TITLE PARKING LEVEL PLAN MECHANICAL		
PROJECT 25 BAKER HILL BLVD. ROYAL PINE HOMES		
STOUFFVILLE, ONTARIO PROPOSED RESIDENTIAL DEVELOPMENT		
DRAWN GC	CHECKED BT	SCALE 1:100
DATE JUNE 2015	PROJECT 14-016	DRAWING M-4 OF 42

SITE INSTRUCTION

PROJECT: HAMPTON MANOR
25 BAKER HILL BLVD
STOUFFVILLE, ONTARIO

SITE INSTRUCTION: M-25

TITLE 1ST FLOOR LEVEL MECHANICAL			
PROJECT 25 BAKER HILL BLVD. ROYAL PINE HOMES			
STOUFFVILLE,		ONTARIO	
PROPOSED RESIDENTIAL DEVELOPMENT			
DRAWN	GC	CHECKED BT	SCALE 1=50
DATE	JUNE 2015	PROJECT 14-016	DRAWING M-8 OF 42

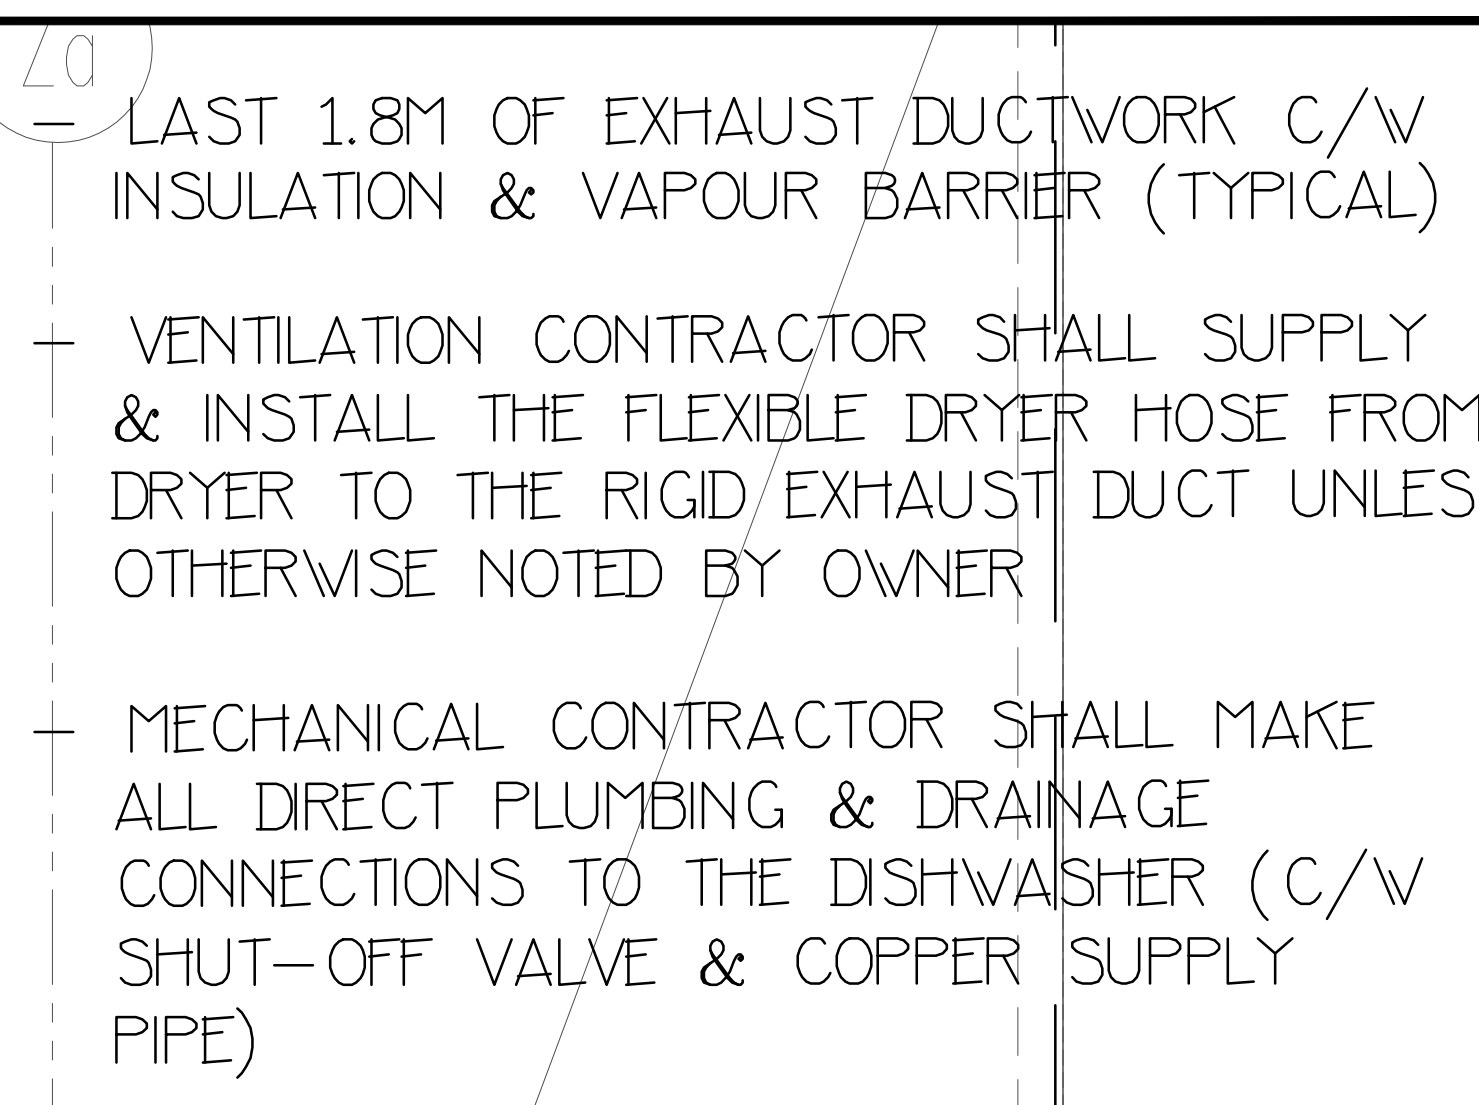
2.0 Reference Drawing M-5, M-8 (1st Floor Level - Mechanical) Issued

2.1 Relocated: Management room fan (F-21) and storage room fan (F-2).

2.2 Relocated: Fresh Air diffuser for mail room.

2.3 Added: Fan (F-2) for new janitor room.

2.4 Added: 20ø cw, hw, and sink for new janitor room.
